Project	IEEE 802.16 Broadband Wireless Access Working Group < http://ieee802.org/16 >	
Title	Fix for Location Update primitive	
Date Submitted	2006-03-08	
Source(s)	ZTE corporation	xu.ling@zte.com.cn
	Xu Ling	
	Mary Chion	
	CATR	
	Gong Daning	gongdaning@catr.com.cn

Re:	Contribution on comments to P802.16g-D1	
Abstract	In this contribution, we propose to amend the protocol through add the new message about Location Update	
Purpose	Adoption	
Notice	This document has been prepared to assist IEEE 802.16. It is offered as a basis for discussion and is not binding on the contributing individual(s) or organization(s). The material in this document is subject to change in form and content after further study. The contributor(s) reserve(s) the right to add, amend or withdraw material contained herein.	
Release	The contributor grants a free, irrevocable license to the IEEE to incorporate text contained in this contribution, and any modifications thereof, in the creation of an IEEE Standards publication; to copyright in the IEEE's name any IEEE Standards publication even though it may include portions of this contribution; and at the IEEE's sole discretion to permit others to reproduce in wh

Figure 498— Location Update Primitives

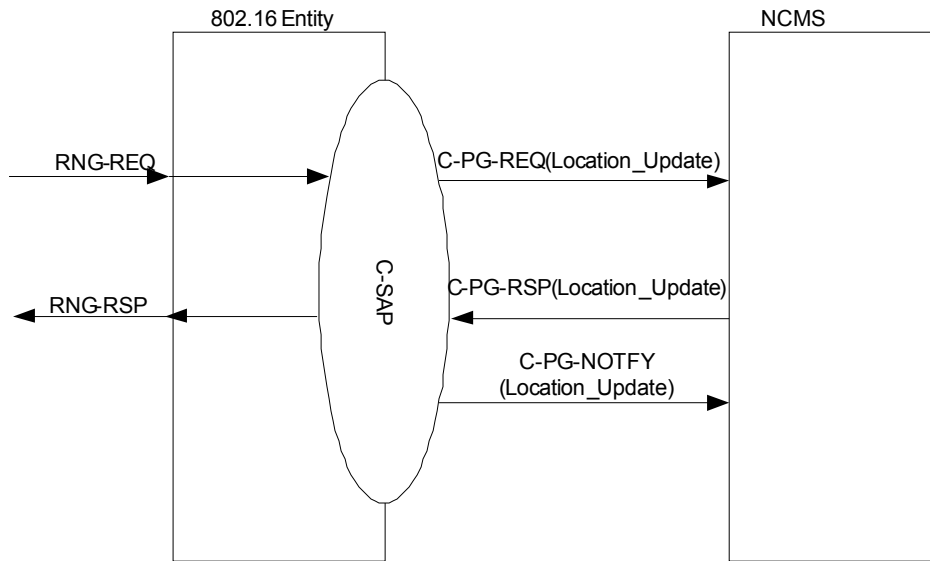
All the above Location Updates are realized by Ranging request/response (RNG-REQ/RSP) message between an MS and a BS, and ~~Location Update request and Location Update response~~C-PG-REQ, C-PG-RSP,C-PG-NOTIFY service primitives are defined between a BS and an NCMS to perform Location Update.

Figure 498 shows service primitives for Location Update between a BS and an NCMS.

[Modify Location Update flow diagram between NCMS and BS as the following]
